January 12, 2015
BOARD OF COUNTY COMMISSIONERS
ORANGE COUNTY, FLORIDA
Addendum No. 2/IFB Y15-725-CH

INTERNATIONAL DRIVE PEDESTRIAN BRIDGE PROJECT (FROM ORANGE COUNTY CONVENTION CENTER TO HYATT REGENCY HOTEL)

Example No. 1 - Staging Area Wall Mural

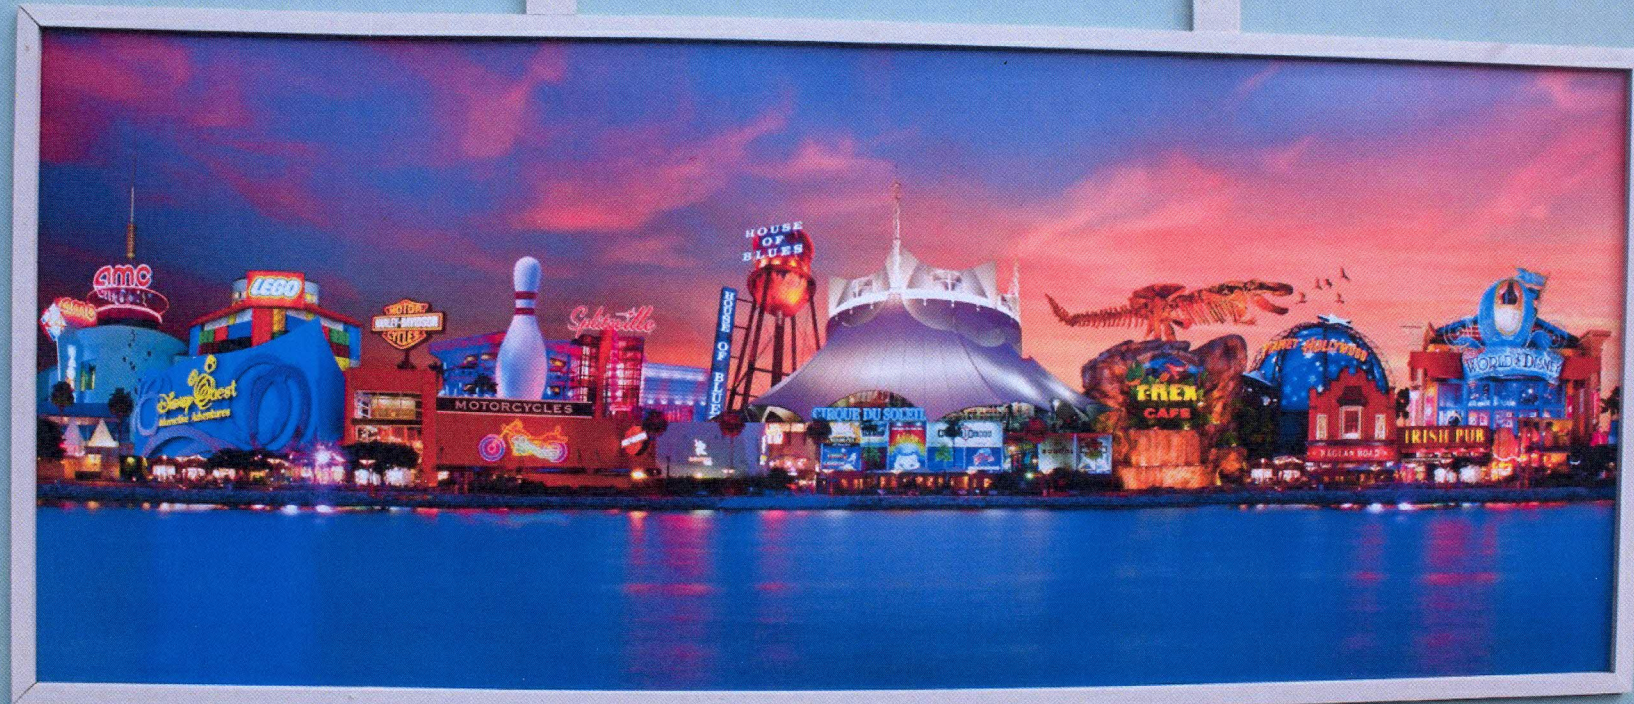
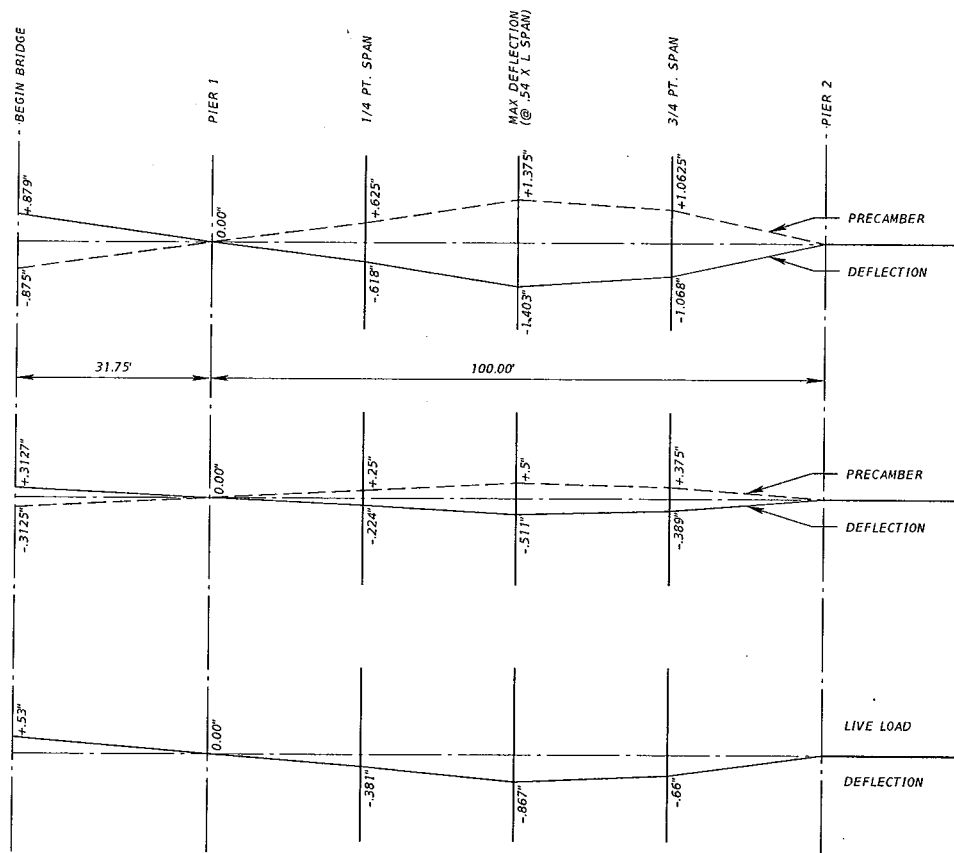
Attached in Addendum #2 are two examples of wall murals to provide clarification/insight on what is being requested.

- 9) **Question:** Special Provisions page G-34 state that app. 40 EA murals sized 4'x12' are to be included on the finish of the temporary barrier walls. Are there any sample drawings or renderings of what murals are to be provided? Do these murals have to be painted or can they be other material such as vinyl or screen print that can be adhered to the barrier walls? Please provide details and/or samples of the artwork or other to be included for these proposed murals so the cost for this work can be included accordingly.

Answer: The murals will be printed on a weather-resistant material and applied to the plywood surface. Application to the surface is at the discretion of the Contractor. The application must keep the "murals" flush with the plywood throughout construction. The murals will be provided to the Contractor as a digital file (.jpeg, .pdf, etc.) and will be the Contractor's responsibility to print the mural per Special Provisions, Paragraph 27 on Page G-34.

UNIT 1 - BEGIN BRIDGE TO PIER 2

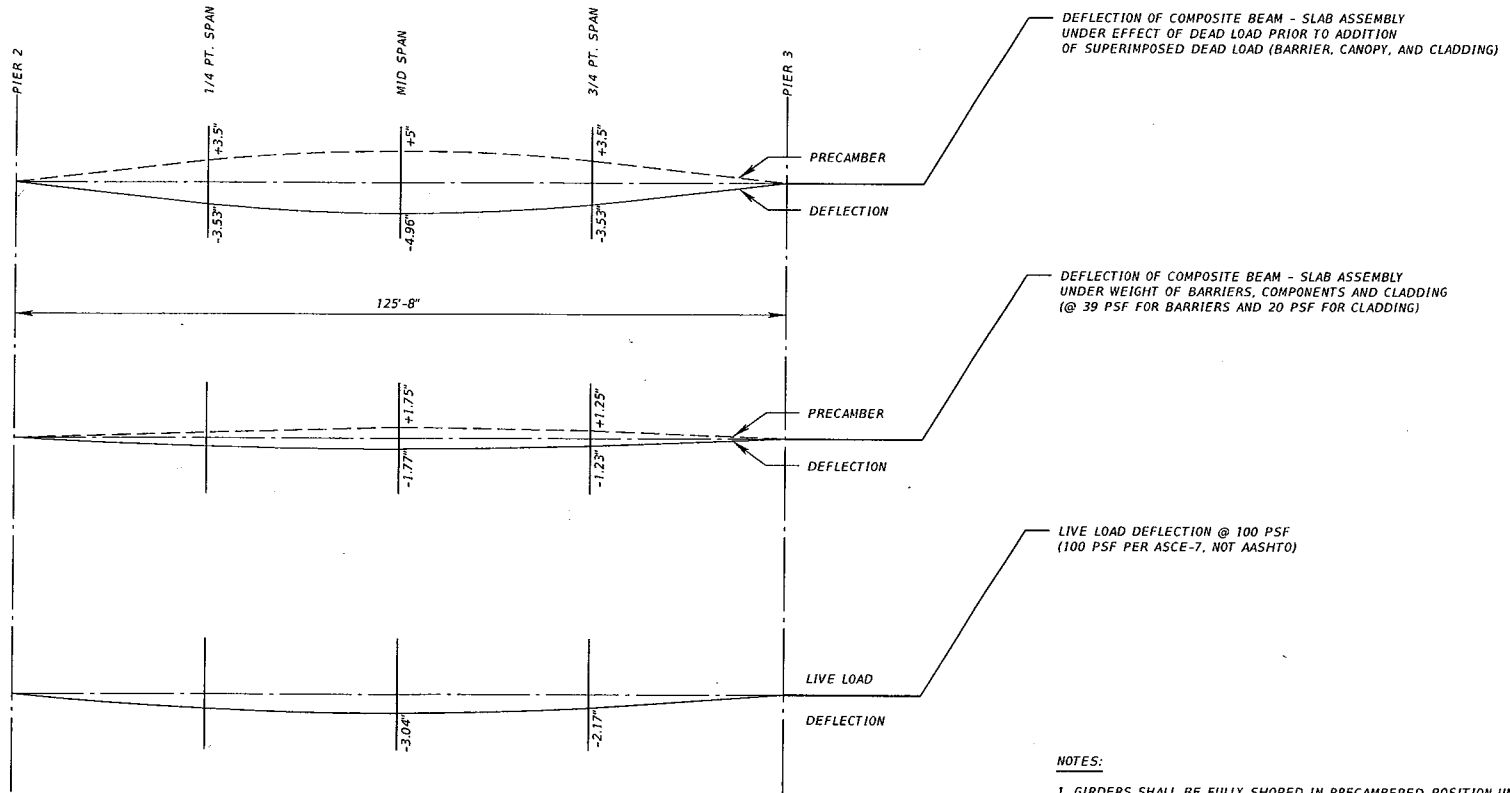
Attached in Addendum #2 Sheet No. B1-26A – Camber and Deflection Diagrams (1) and Sheet B1-26B – Camber and Deflection Diagrams (2) have been added.

- 37) **Question:** Please provide a camber detail for the bridge girders.

Answer: Slabs are cast in place, off-site, on fully shored girders and attached per Detail A on Sheet B1-25. Girders must be precambered and remain shored until concrete has reached its full strength, see the Attachment for camber and deflection diagrams.

Answer: See Drawing Sheets B1-26A and B1-26B attached in this Addendum.

- GIRDERS SHALL BE FULLY SHORED IN PRECAMBERED POSITION UNTIL CONCRETE HAS REACHED DESIGN STRENGTH.
- PROVIDE A FULL DEPTH END DIAPHRAGM ALONG SKEW AT BEGIN BRIDGE FOR BALLAST TO PREVENT UPLIFT (1'-0" THICK, 2'-8" DEEP, #5 EWEF)
- MINIMUM BUILD-UP ON INTERIOR GIRDERS IS 1". MINIMUM BUILD-UP ON EXTERIOR GIRDERS IS 1-1/2".
